**ADERRIG PHASE 2,
ADAMSTOWN,**

RFI RESPONSE :

**ARCHITECTURAL
COMMENTS**

OCTOBER 2021

Managed Landscaped gable strips at St. Helens Phase 2, Adamstown

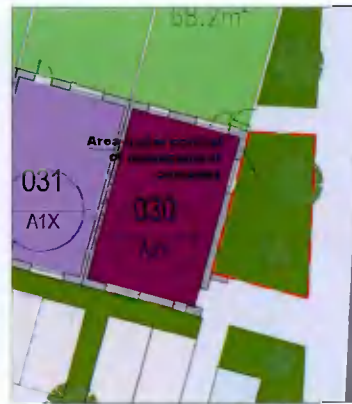
3 (1) (a) Slivers of land to the side of a number of dwellings, which ideally should act as privacy strips for the respective dwellings are proposed to be taken in charge.

The landscaped strips located at the gable ends of House Numbers, 17, 21, 30, 37, 66, 69, 75, 80, 87, 92, 153, 159, 166, 167 and 171, have been denoted as being maintained by a private management company. It is not proposed that any of these spaces are taken in charge by the Council. We respectfully contend that this approach will ensure that appropriate, high-quality landscaping is maintained at all times along gables and exposed walls within the development. This approach will deliver a far more visually consistent environment and higher quality streets, than one in which the maintenance of these small strips is left to individual house owners. This approach is currently implemented on schemes within the SDZ and is working well (photos from St Helens, Gandon Park and Shackleton (Adamstown) on the following pages.

Units adjoining gated and secure communal garden spaces

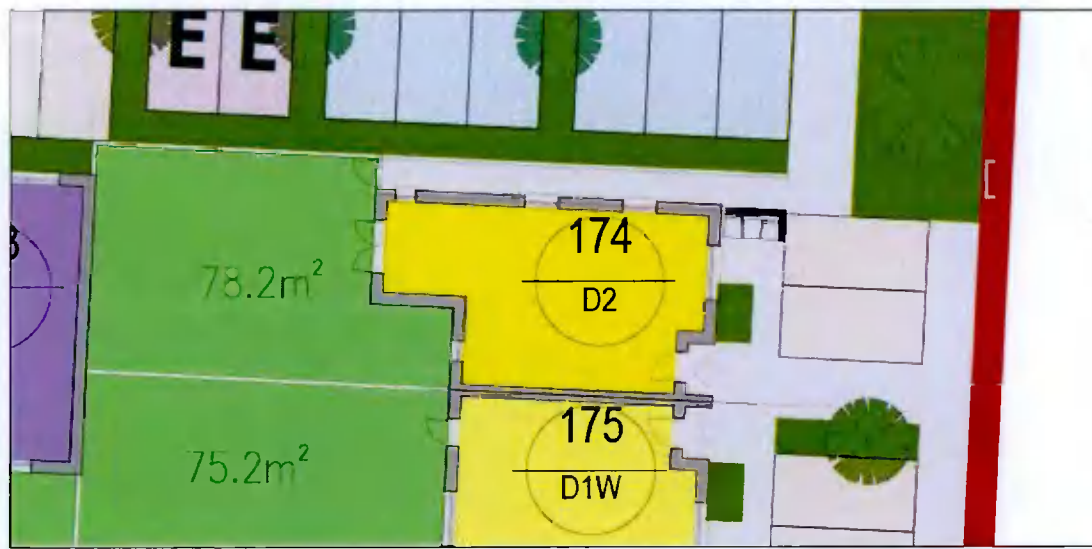
- (xix) to the south of dwelling number 185 (house type D2 – as requested in item c. below)
- (xx) to the south of dwelling number 198 (house type C2+ as requested in item d. below)

to be incorporated into the landownership of each of these dwellings and where appropriate a low wall and railing (maximum height of 1.2m) or similar design measure to be provided to separate the private realm and the public realm and to enclose these required privacy strips along the side elevation of the dwellings.

Both unit 185, and 198 have south facing gable walls adjoining an area of gated communal open space for the sole benefit of the duplex units in the south east corner of the site adjoining Adamstown Way (units – 186, 187, 188, 189, 190, 191, 192, 193, 194, 195, 196, 197). This communal space will be maintained by the management company and includes a bin store, bike store and soft landscaped areas with security-controlled access gates and railings at the western and eastern ends. The communal space will be well supervised by the duplex units to the south which overlook it, and who will be the sole users of the space.

Units 185 and 198 are houses located on Linear Park Road and Side Street 4 respectively which will not have access to this communal area, having private rear gardens instead. On this basis we respectfully contend that it is neither appropriate nor desirable to locate C2+ or D2 units along the northern boundary. This would result in gable windows looking into a shared communal area to which the houses will not have access. Similarly, we contend that a private strip along the southern gables of these units would be unnecessary, given the fact that the management company will be maintaining this area in line with the strategy for the rest of the development.

Adjustment to position of Duplex block at SE corner on Adamstown Way

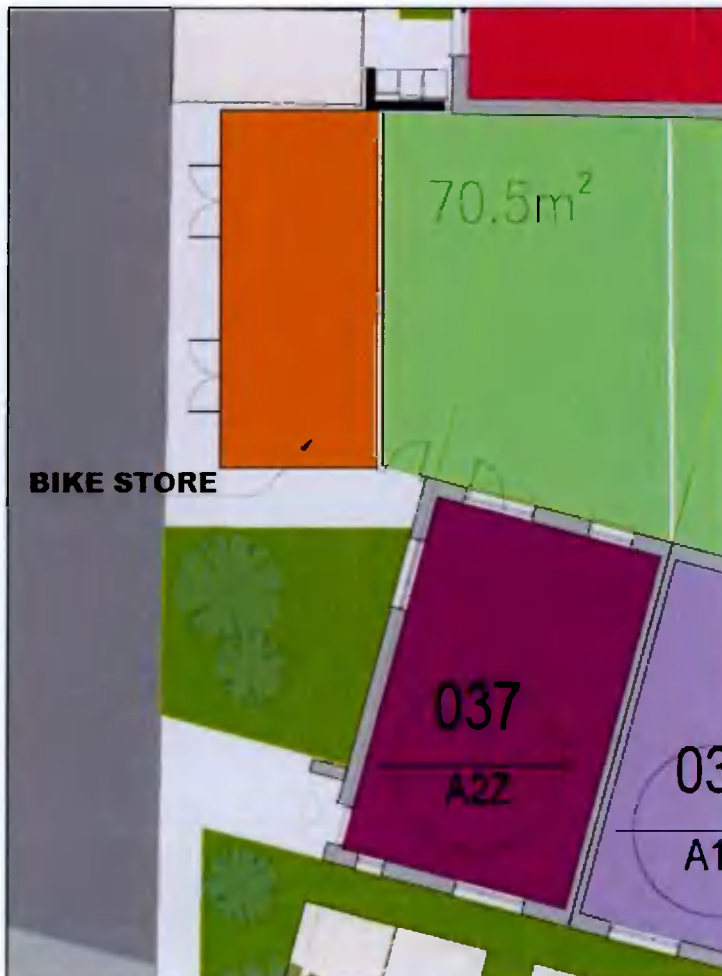
(e) Amend Dwelling no. 205 to provide a significant privacy strip along its eastern side (minimum of 0.9m). This may require a slight realignment of the southern Duplex block.

The duplex block has moved in a westerly direction as requested. (see drawing Drg 6259 -P-003 for detail).
